Addendum No: 2
Date: January 12, 2024
Owner: Northern Health
Stantec # 144320228

This addendum is to be read with and constitutes part of the tender document.

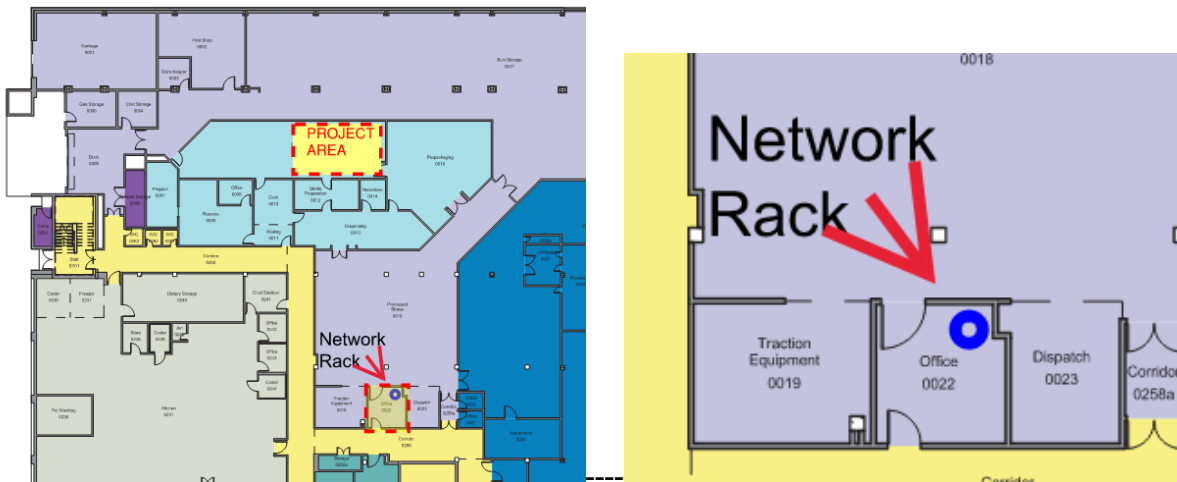
Question: Please confirm where the closest Data closet is located to confirm our cable distances.

Answer: The closest data closet is located as per drawing below, and is situated on Level 0 as per plans below.
